NEWMAR CORPORATION WARRANTY DEPARTMENT

TECHNICAL SERVICE BULLETIN							
DATE ISSUED	MODEL YEAR(S) AFFECTED		MODEL(S) AFFECTED			TSB #	
3/31/08	2007-2008		All DP on Freightliner Chassis			329	
BRAND						TYPE	
All	<input type="checkbox"/>	American Star	<input type="checkbox"/>	Mountain Aire	<input type="checkbox"/>	All	<input type="checkbox"/> TT <input type="checkbox"/>
Cypress	<input type="checkbox"/>	Dutch Star	<input checked="" type="checkbox"/>	Kountry Aire	<input type="checkbox"/>	FW	<input type="checkbox"/> CA <input type="checkbox"/>
Northern Star	<input type="checkbox"/>	Kountry Star	<input checked="" type="checkbox"/>	Essex	<input type="checkbox"/>	DP	<input type="checkbox"/> DB <input type="checkbox"/>
Scottsdale	<input type="checkbox"/>	King Aire	<input type="checkbox"/>	London Aire	<input type="checkbox"/>		
All Star ME	<input type="checkbox"/>	Ventana	<input checked="" type="checkbox"/>				
<input type="checkbox"/> Air Conditioning & Heating <input type="checkbox"/> Appliances & Accessories <input type="checkbox"/> Cabinets & Furniture <input checked="" type="checkbox"/> Chassis Components <input type="checkbox"/> Construction Components				<input type="checkbox"/> E

Fig. 1, Data Plate Identification

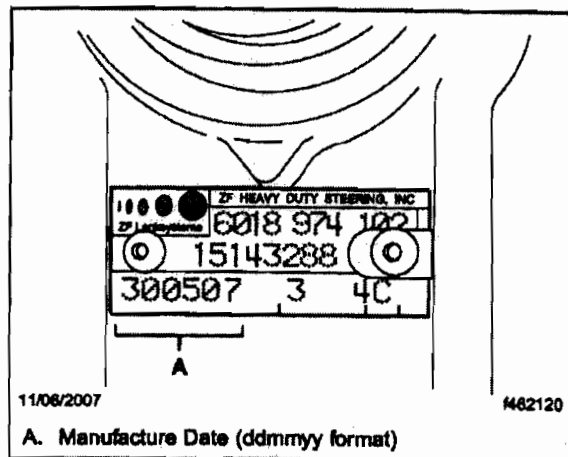
1. Check the base label (Form WAR259) for a completion sticker for FL509 (Form WAR280) indicating this work has been done. The base label is usually located on the front wall under the dash in motorhomes. If a sticker for FL509 is present, nothing further needs to be done. If a sticker is not present, go to the next step.
2. Shut down the engine, set the parking brake, and chock the tires.
3. Check the date code on the data plate of the steering gear. See Fig. 1.
 - 3.1 If the date code is 250407 or more, nothing further needs to be done. Go to step 4.
 - 3.2 If the date code is less than 250407 go to "Steering Gear Replacement."
4. Clean a spot on the base label, write the Recall number, FL509, on a blank completion sticker, and attach it to the base label.
5. Remove the chocks from tires.

Fig. 2, Steering Gear Mounting Bolts

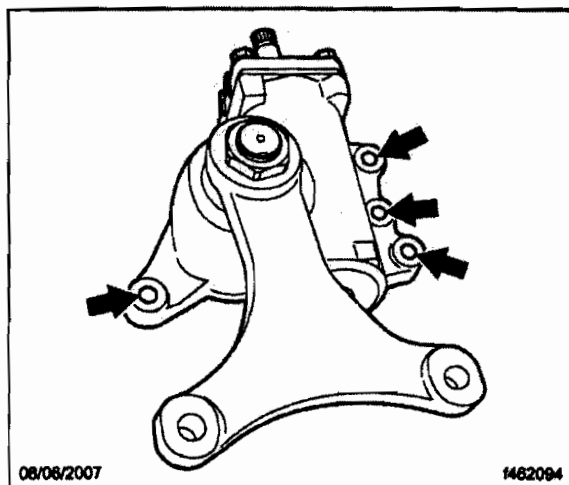
5. Remove the steering gear.
 - 5.1 Using a 1-3/16 impact socket, loosen the four mounting bolts. See Fig. 2.

- 5.2 Remove three nuts, leaving the centermost assembled in order to prevent the steering gear from falling.
- 5.3 Position 1 x 4 boards (as needed) across the lower control arms, and use a transmission jack to support and receive the gear when it's disconnected. Remove the last nut, lower the gear, and remove to one side.

- 6.3 Install all remaining nuts, then tighten all four nuts 378 to 462 lbf-ft (18 to 22 N-m).
 - 6.4 Connect the pressure and return hoses to the steering gear.
